CONCEPT PLAN III
STREET BAPTIST
ALEXANDRIA, VIRGINIA

Mr. Michael Swidrak, AICP
Urban Planner
City of Alexandria
Development Division
301 King Street
Room 2100
Alexandria, VA 22314

We are in receipt of your comments dated June 21, 2016. Many changes have been incorporated into this submission based on City Staff as well as Community input, including adding a third level of underground parking on site. As a result, the Applicant is submitting this Concept III submission so Staff has the most current plans being proposed. The following are our responses to your comments:

CONCEPT PLAN

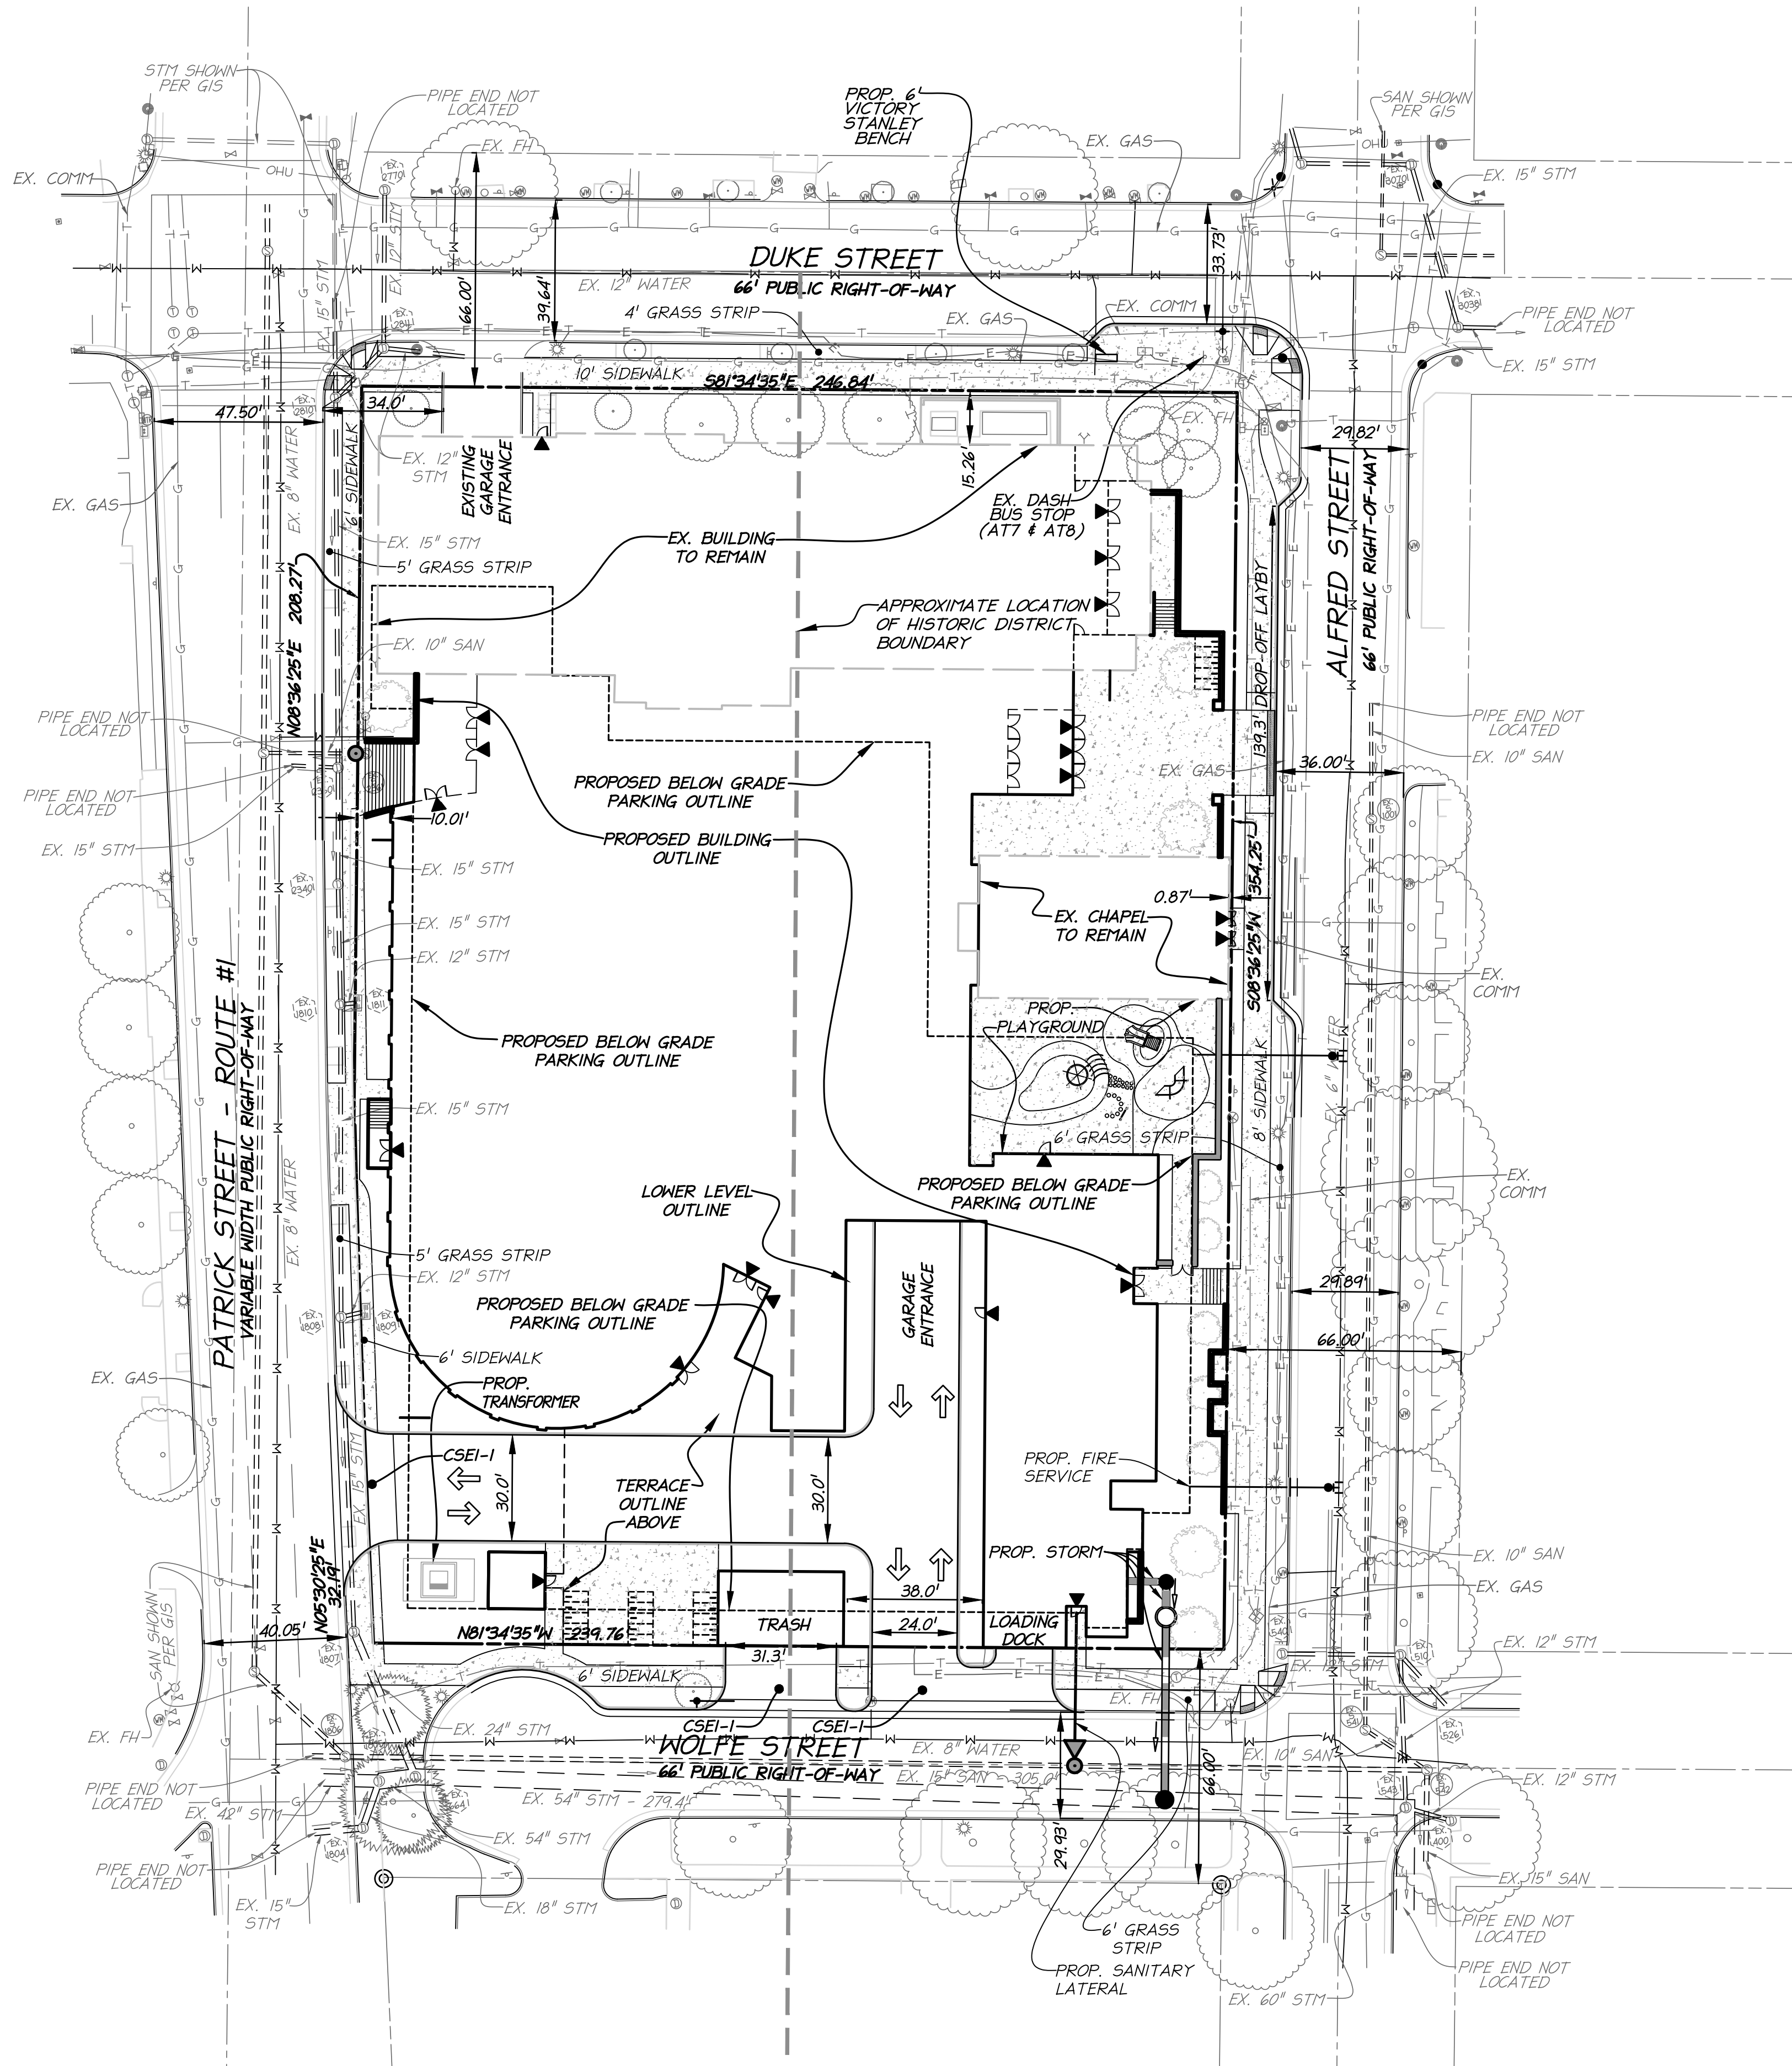
9. Sheet C400: Provide garage slope in the site plan that must be less than 10% or maximum 12% with winter treatment. 15% slope is not acceptable. (I-ROW/Transportation)

10. Show conceptual location of transformers and switch gears. (I-ROW)

24. On sheet C400 – the proposed bulb along Duke Street shall be designed to allow a bus to safely mesh against the curb of the bulb without hitting a parked car to the west of the bulb in the parking lane. The curb of the bulb should be flush with the parking lane limit. (Transit)

29. Sheet C400 – Provide ADA compliant bus stop loading pad at existing bus stop location on Eastbound Duke Street. Provide standard U-channel pole to be installed at a location specified by DASH's Bus Stop Coordinator. Pole mounting location must be minimum 2 feet clearance from curb edge. (DASH)

30. Sheet C400 – Provide clarified site plan on streetscape plan, including bus stop details. (DASH)

Response: Both entrance/exit ramps to the garage are less than 15%.

Response: Refer to sheet C400 for location (SW corner).

Response: Acknowledged.

Response: Acknowledged.

Response: This level of detail will not be provided with the Concept Plan. To be provided with Completeness Submission.
